Re: 357 Crow Hill Road, Mount Kisco, NY  
Application for Minor Subdivision  
Tax Map Parcel 70.08-1-8 ("Property")

We last appeared before the Board on November 4, 2024 when we had our public informational hearing. Since that time we have revised our plans to include our proposed method of treating first flush stormwater runoff for the proposed lot. We have also added the dead end fire apparatus access road turnaround that conforms to Appendix D of the 2020 Fire Code of New York State.

SKETCH  
SUBDIVISION PLAN

### ENLARGED DRIVEWAY PLAN

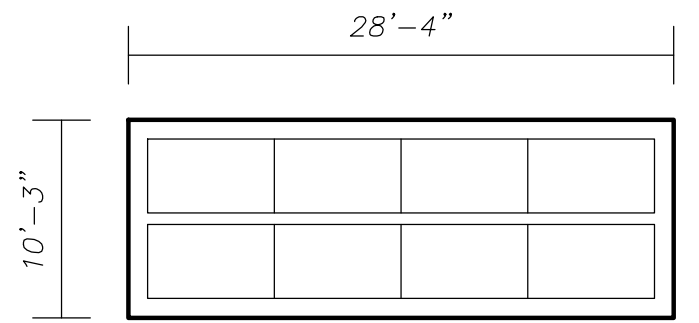
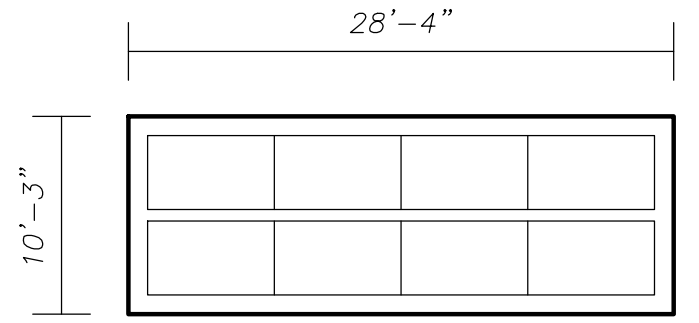
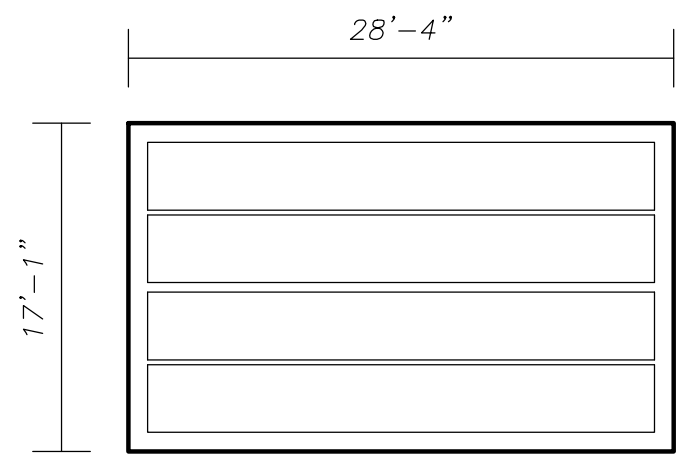
NO.	DATE	DESCRIPTION
1	9/1/24	REVISED LOT 1 HOUSE LOCATION + DRIVEWAY
2	11/8/24	ADDED INFILT. AREAS, SHIFT WELL
3	1/29/25	REVISED DRIVEWAY

### DEAD END FIRE APPARATUS ACCESS ROAD TURNAROUND

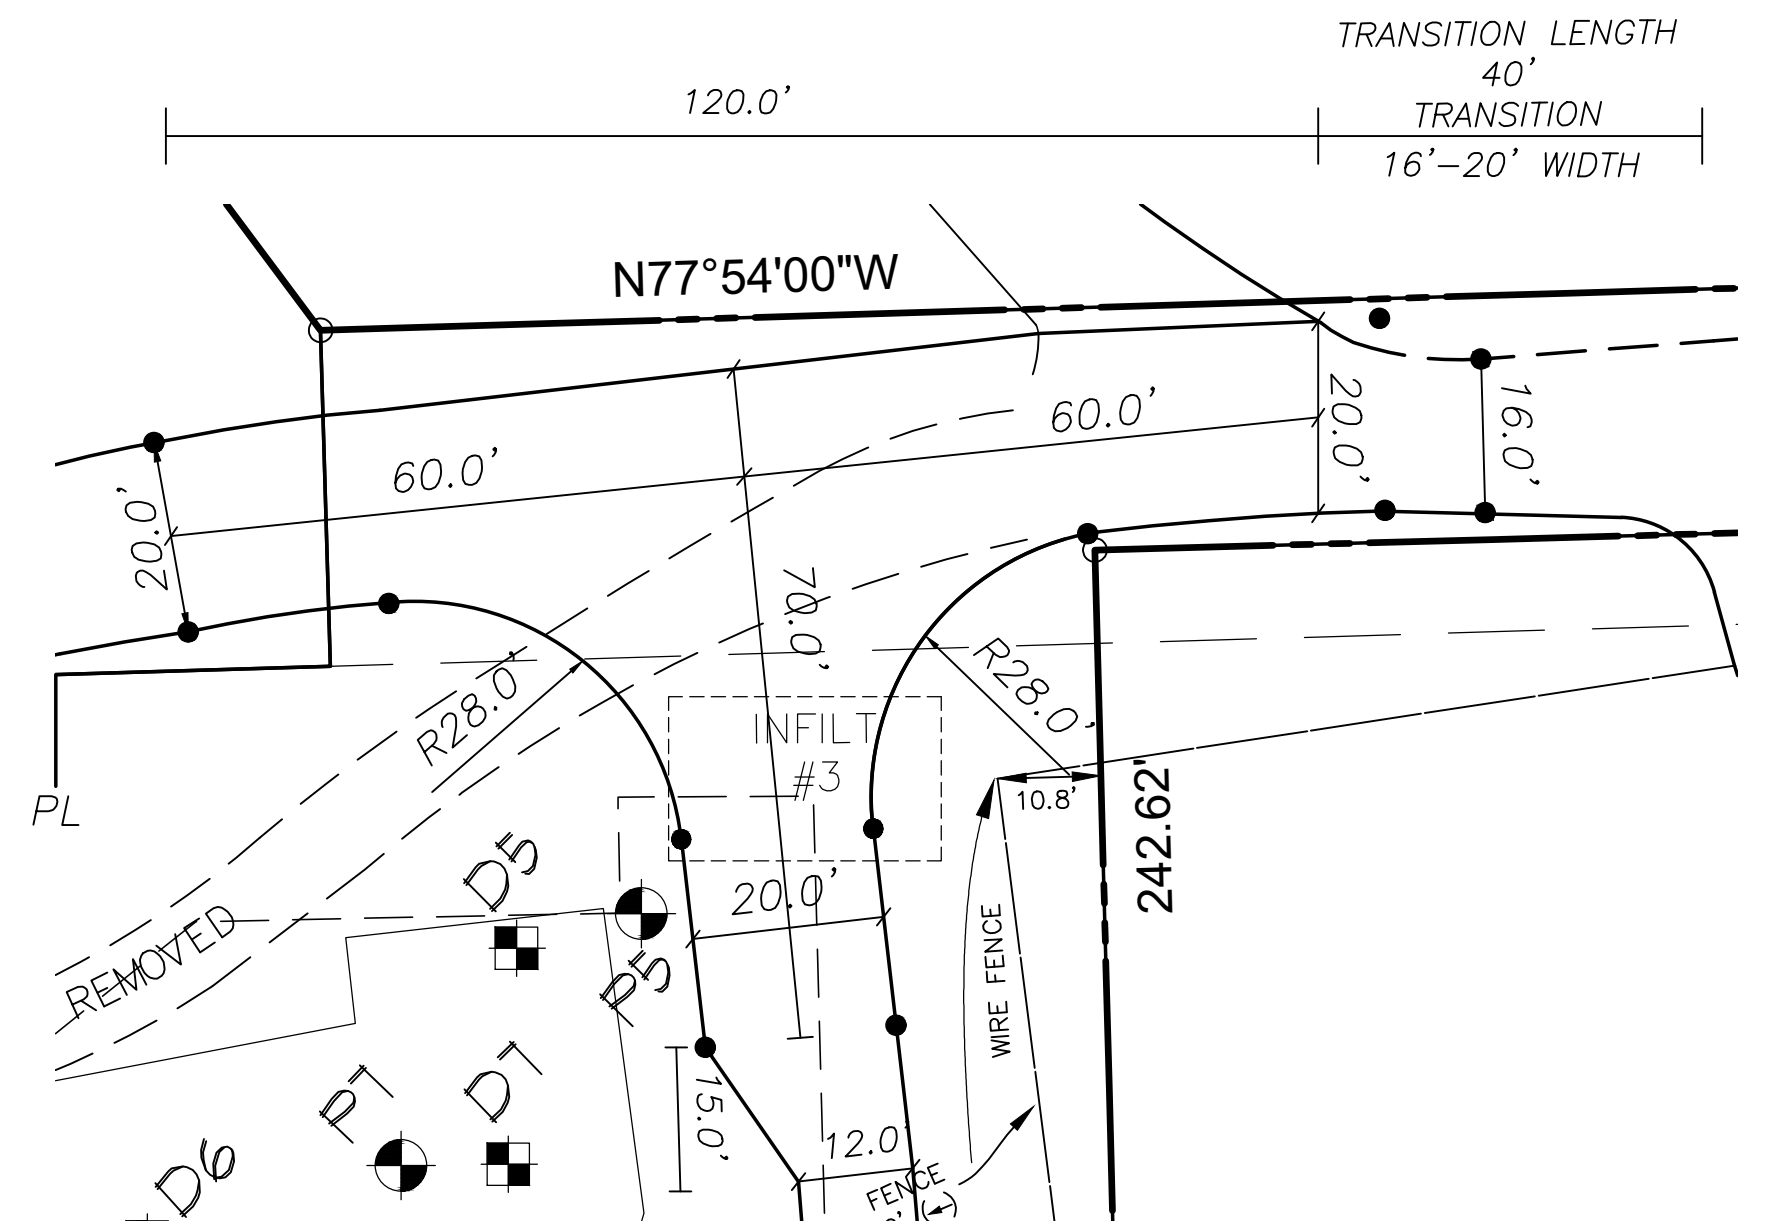
NO.	DATE	DESCRIPTION
1	9/1/24	REVISED LOT 1 HOUSE LOCATION + DRIVEWAY
2	11/8/24	ADDED INFILT. AREAS, SHIFT WELL
3	1/29/25	REVISED DRIVEWAY
